PLANNING COMMISSION MEETING
Monday, May 10, 2021 – 7:00 p.m.
Zoom Meeting
Meeting ID: 840 7156 1960
Password: 461294

Farmington Planning Commission Staff Report	Planning Commission Date: May 10, 2021	Reference Number 4
Submitted by: Kevin Christiansen, Economic and Community Development Director		
Description Site Plan Review – Proposed Building Addition, MI.Mosa Restaurant, 23360 Farmington Road		
<p><u>Background</u></p> <p>This item is a review of a proposed building addition for the existing MI.Mosa Restaurant. The proposed building addition is intended to be located in the rear of the existing restaurant covering/enclosing the existing rear on-site outdoor seating area. At their May 6, 2021 meeting, the Downtown Development Authority (DDA) Design Committee reviewed and recommended the proposed building addition for MI.Mosa to the Planning Commission in accordance with the submitted plans (see attached meeting minutes). No changes regarding building dimensions or to the exterior of the existing restaurant building, or other site improvements are proposed.</p> <p>The applicant has submitted plans for the proposed building addition, including a proposed site plan, proposed build

DATE: 03.08.21 | SCALE: AS NOTED | DRAWN BY: KT | APPROVED BY: SS | JOB NO: 2103 | SHEET NAME: PROPOSED SITE PLAN | SHEET NO: SPA-100

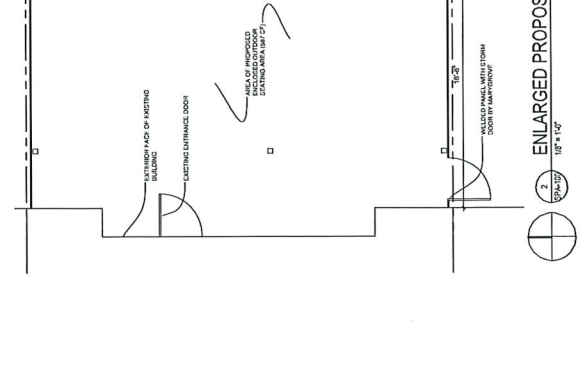
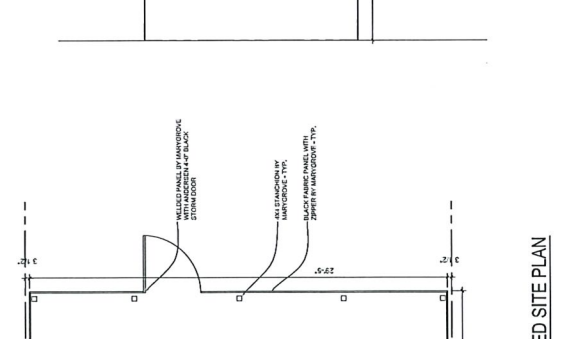
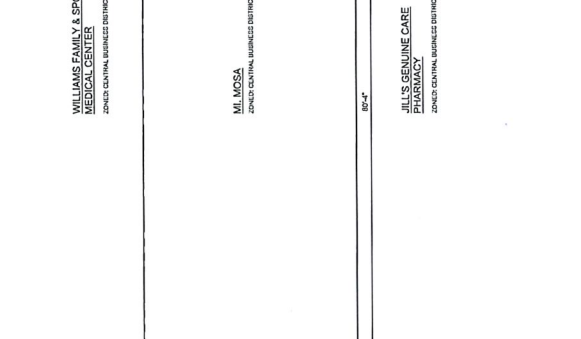
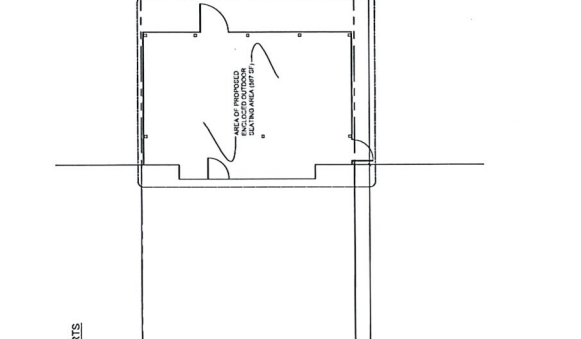
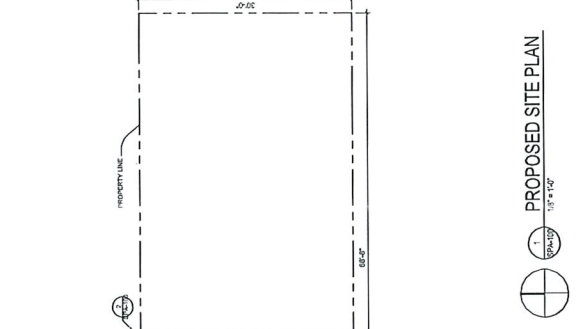
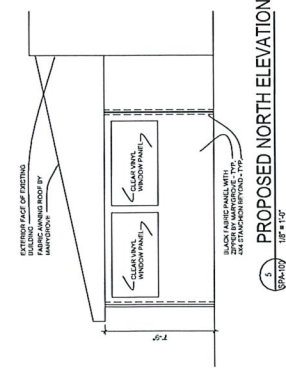
This enclosure could have a shorter lifespan than more permanent building materials. If this starts to fade or peel in a few years, committee inquired what means are available to encourage them to repair or replace. Christiansen confirmed that they are required to maintain it.

Committee recommends matching black stanchions and awnings plus planters, or other features, to dress up the appearance, adding planter boxes, or piers, that would define the perimeter when the sides are not being used.
